Re: Sandusky County
Sycamore Hills Golf Course
Sewerage

September 29, 2011

On July 20, 2011, and September 8, 2011, inspections were conducted of the wastewater treatment plant (WWTP) which serves the Sycamore Hills Golf Course. The golf course is located on the north side of U.S. Route 6, approximately one mile west of State Route 53, Washington Township. Observations and recommendations noted during the inspection are as follows:

Sycamore Hills Golf Course WWTP, Sandusky Co.
taken by M.B. Cohen, 09/08/2011

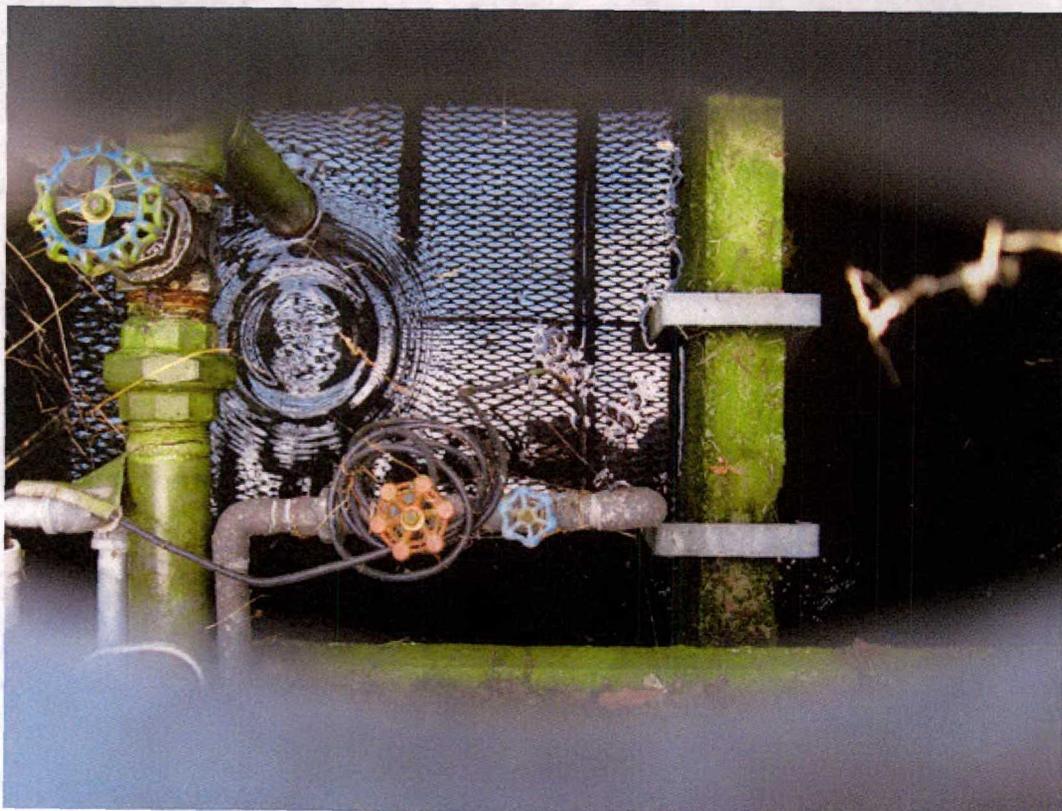
1. The plant was operating, but the tanks had very little aeration. The aeration lines should be inspected and repaired as needed.
2. Two sludge returns were operating with a slightly turbid return flow. The clarifier hopper walls should be scraped down once per day to increase the solids returned.
3. The skimmer was operational.
4. The sand filter walls have been damaged (due to flooding) and only a portion of each filter was in use. The filters need to be repaired and/or replaced.
5. The sand filters also need to be kept clean, level and free of weed growth at all times.
6. Chlorination / de-chlorination must be provided from May through October.
7. Pictures taken at the time of the two inspections are enclosed. Muskellunge Creek was overflowing it's banks and the lower parking lot was flooded at the time of the 09/08/11 inspection as a result of heavy rains.
